CITY OF ALBUQUERQUE

**RE: Route 66 Lofts
7600 Central Ave SW
Grading and Drainage Plan
Engineer's Stamp Date: 11/17/23
Hydrology File: K10D065**

Design Development
Grading Plan

C-200

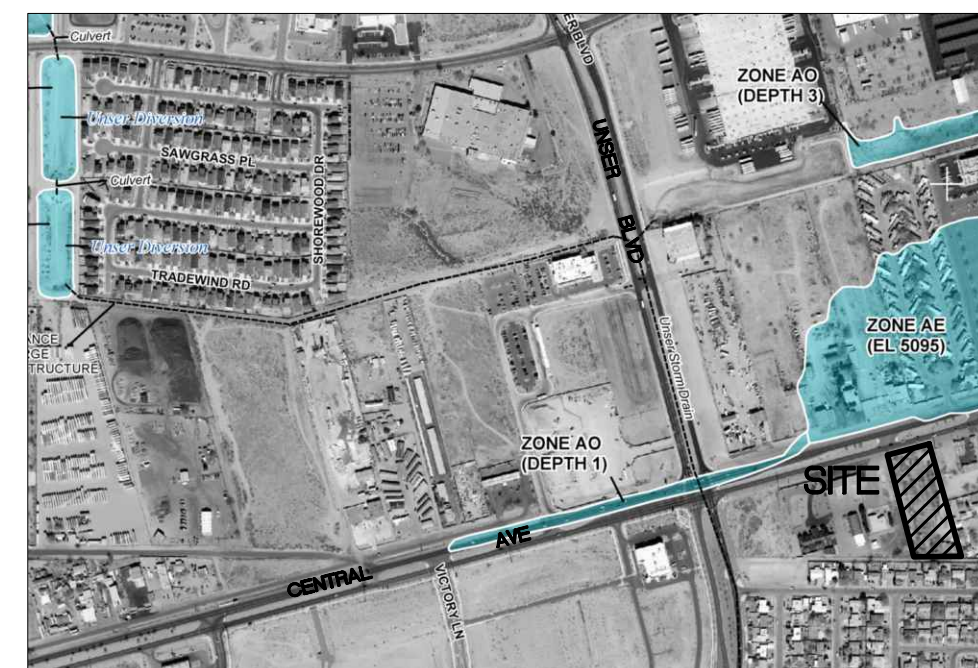
Based upon the information provided in your submittal received 11/23/2023, the Grading & Drainage Plan is approved for Building Permit and Grading Permit. Please attach a copy of this approved plan in the construction sets for Building Permit processing along with a copy of this letter.

1. Engineer's Certification, per the DPM Part 6-14 (F): *Engineer's Certification Checklist For Non-Subdivision* is required.
2. Please provide the executed paper Drainage Covenant (latest revision) printed on one-side only with Exhibit A and a check for **\$25.00** made out to "**Bernalillo County**" for the stormwater quality ponds per Article 6-15(C) of the DPM to Hydrology for review at Plaza de Sol.
